25 Gbaud PAM-4 transmission and mode partition noise RE: comments 4 & 10 against D1.1

IEEE P802.3cm 400 Gb/s MMF Task Force
IEEE 802.3 Interim, Long Beach, CA, January 2019

Penalties vs. length at 850 nm 10°C

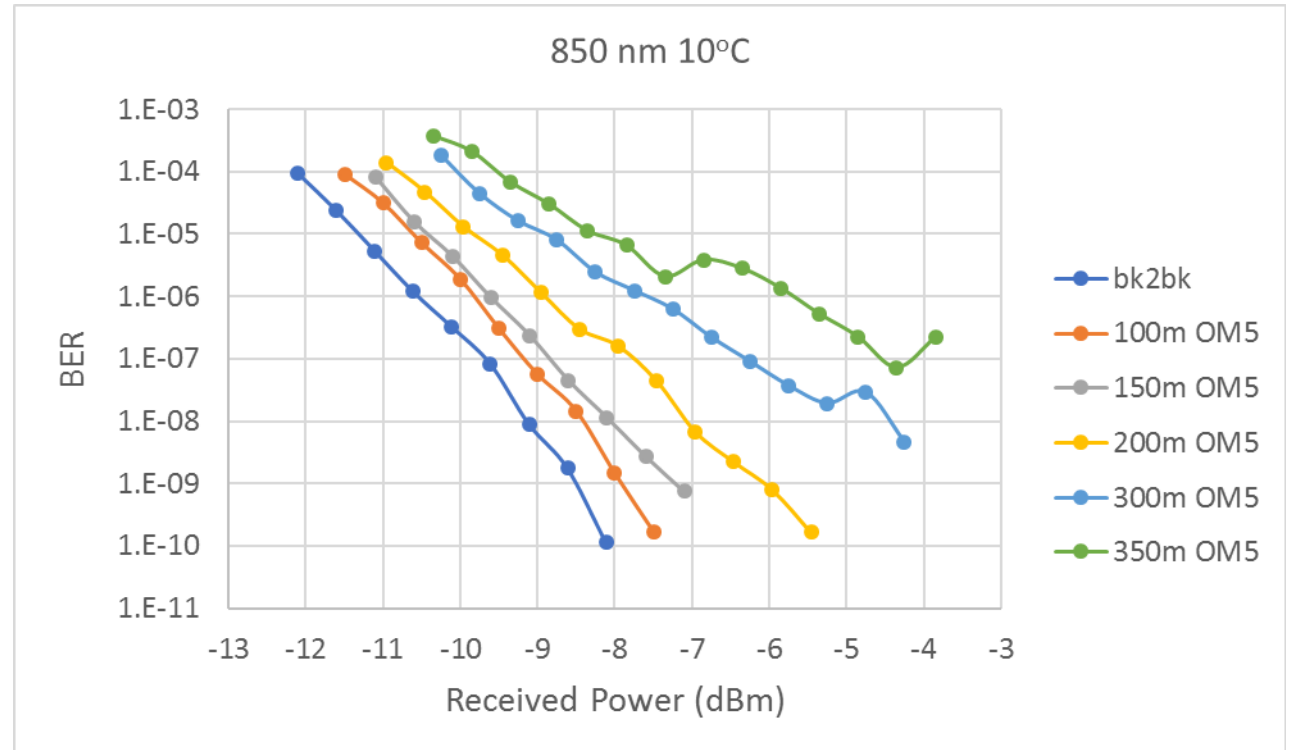
Length (m)	Transmission Penalty @1e-5 (dB)
100	0.7
150	0.9
200	1.5
300	2.4
350	3

Penalties vs. length at 850 nm 31°C

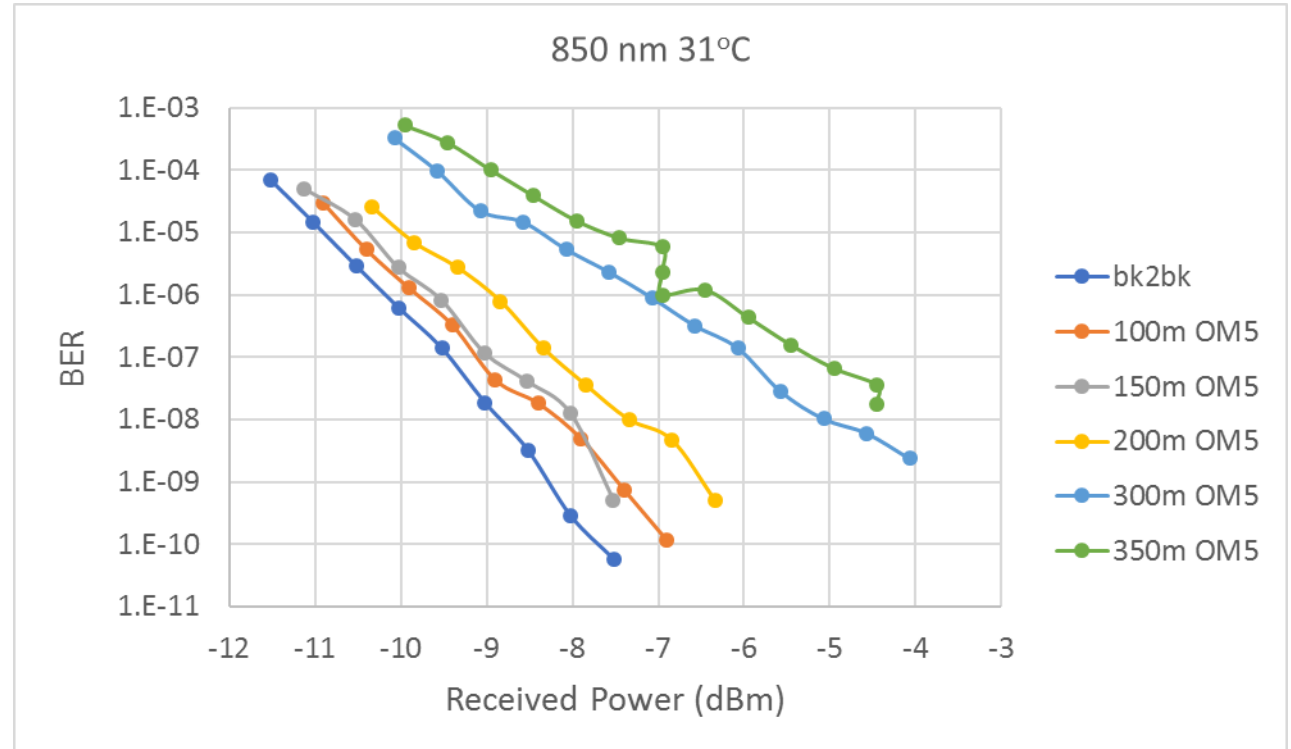
Length (m)	Transmission Penalty @1e-5 (dB)
100	0.3
150	0.5
200	0.9
300	2.5
350	3.3

Penalties vs. length at 910 nm 10°C

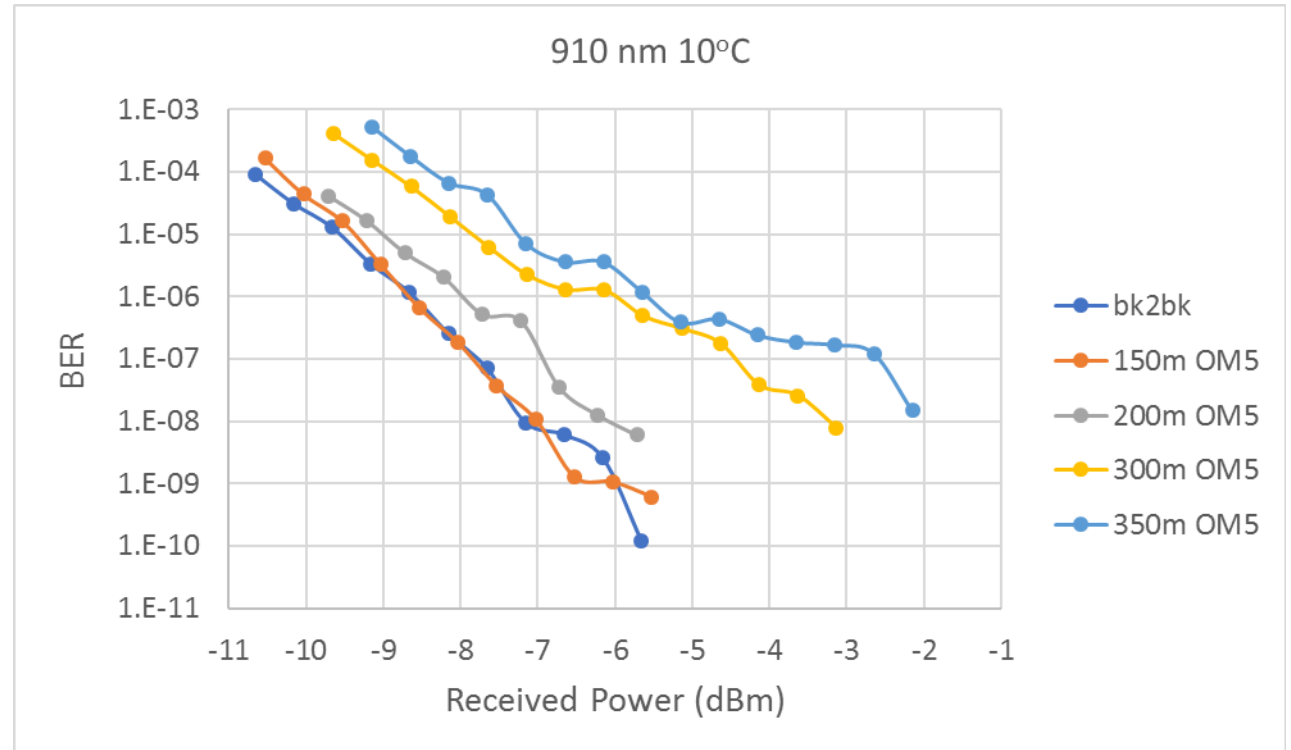
Length (m)	Transmission Penalty @1e-5 (dB)
150	0.2
200	0.6
300	1.7
350	2.3

Penalties vs. length at 910 nm 31°C

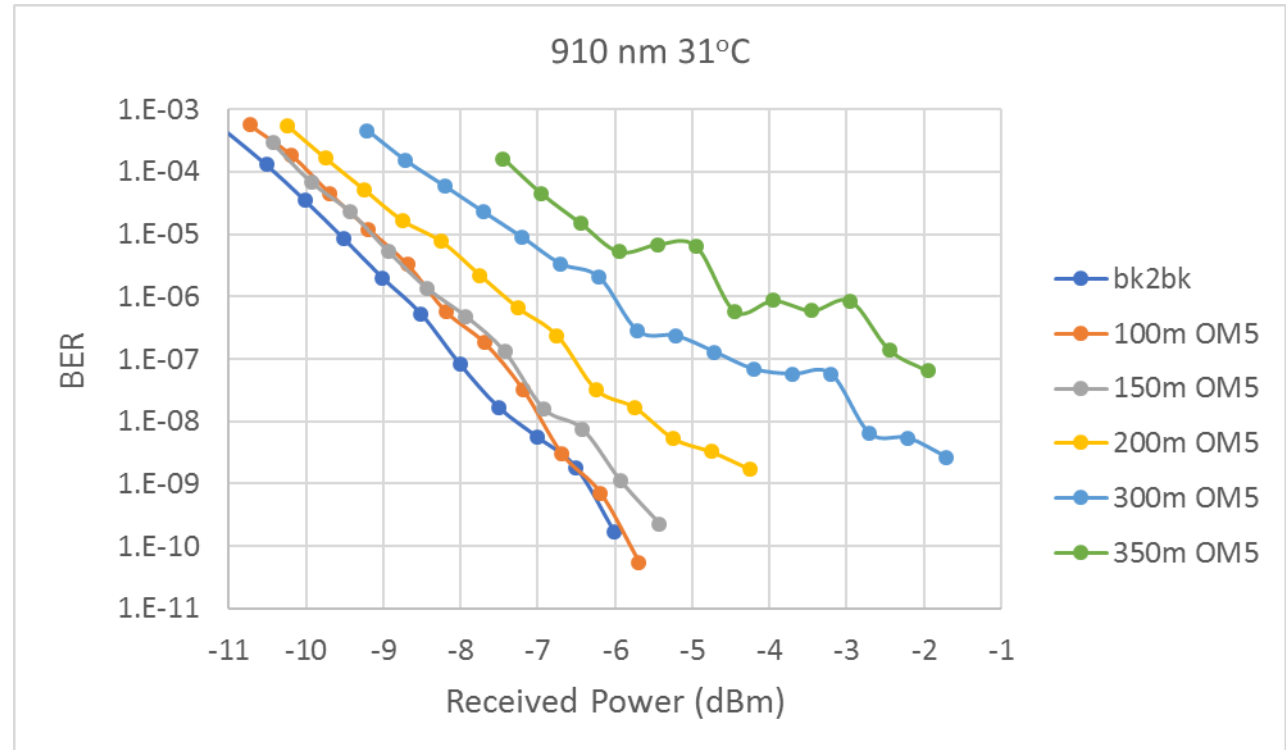
Length (m)	Transmission Penalty @1e-5 (dB)
100	0.5
150	0.5
200	1.2
300	2.3
350	3.3

Total penalties with modal noise generator and 150m OM5 fiber at 855 nm at 31°C with worst-case EMB

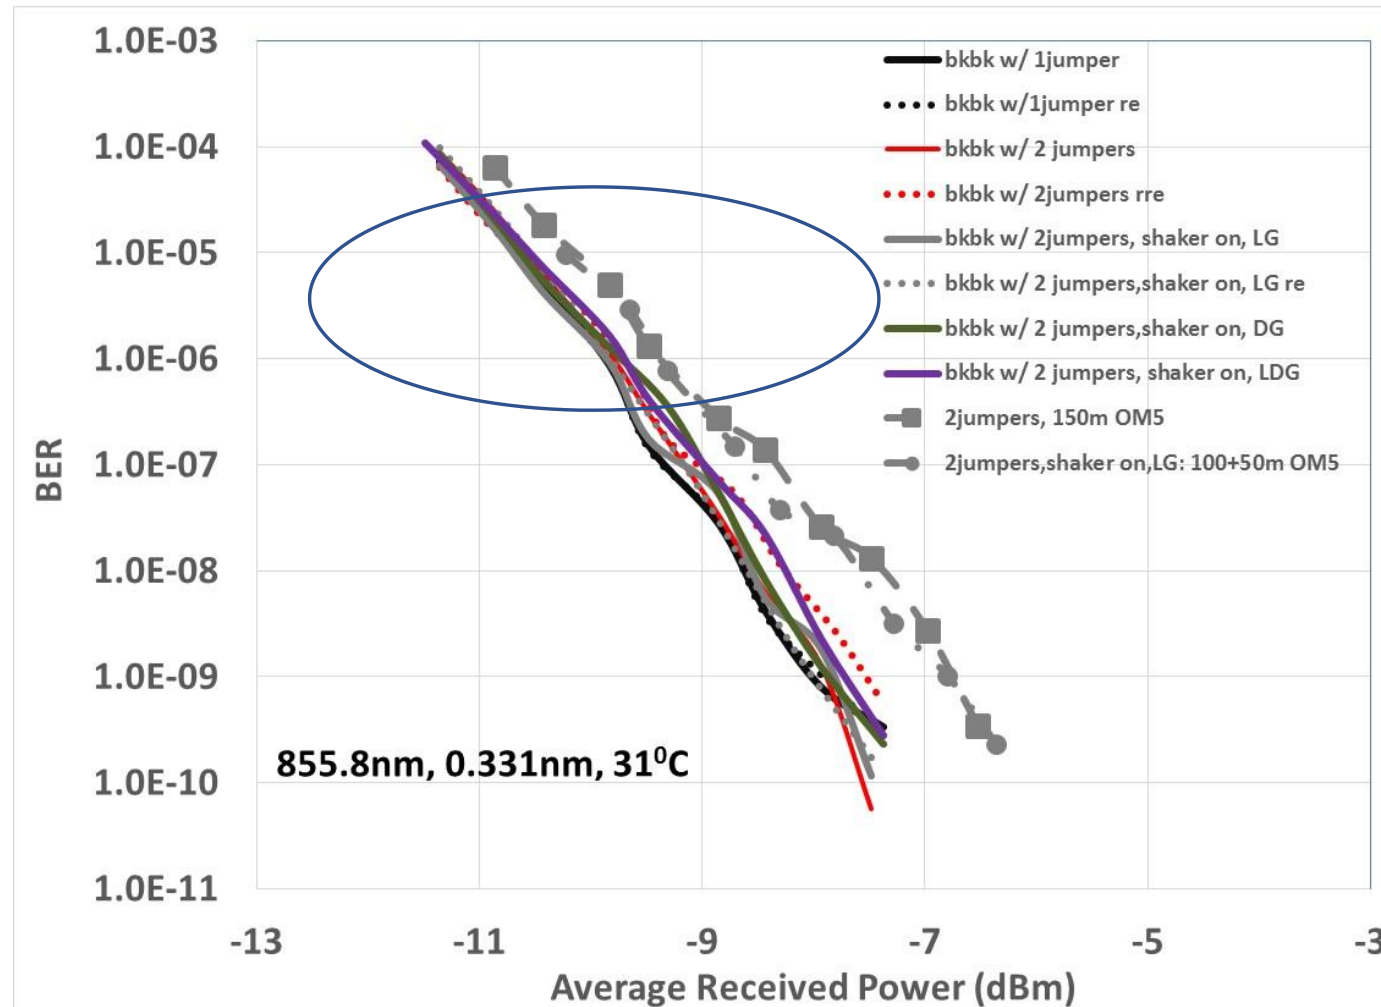
- Total penalty at 150m averages ~ 0.5 dB
 - Total penalty at 300m averages ~ 2.2 dB
 - One experiment found a 0.5 dB penalty for 150m with worst-case fiber with modal noise injected using a shaker & offsets, with 0.33 nm RMS spectral width VCSEL

Dependence of calculated Ogawa-Agrawal MPN penalties on several input parameters

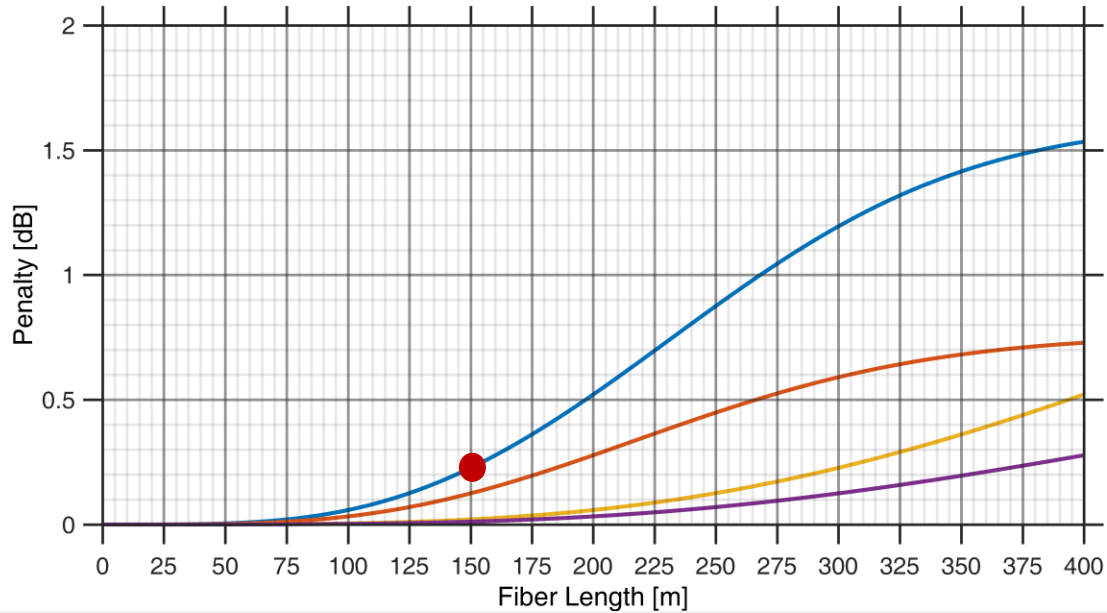
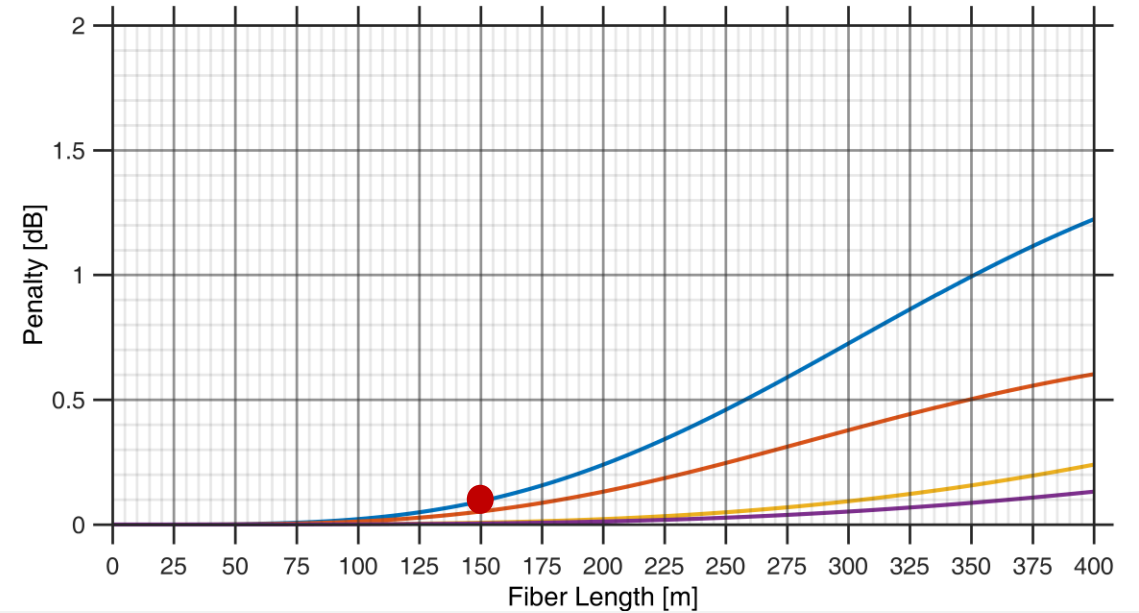
- Dawe has noted values ranging from 0.3 to 0.55 dB relevant to SR4.2

- Simple Ogawa-Agrawal theory indicates a pure MPN penalty in the range of 0.3. to 0.4 dB for 150m links with 0.6 nm RMS. However, we believe this is an over-estimate because of the following:

- It is not clear that there is any reason to increase the MPN penalty allocation for SR4.2 budget
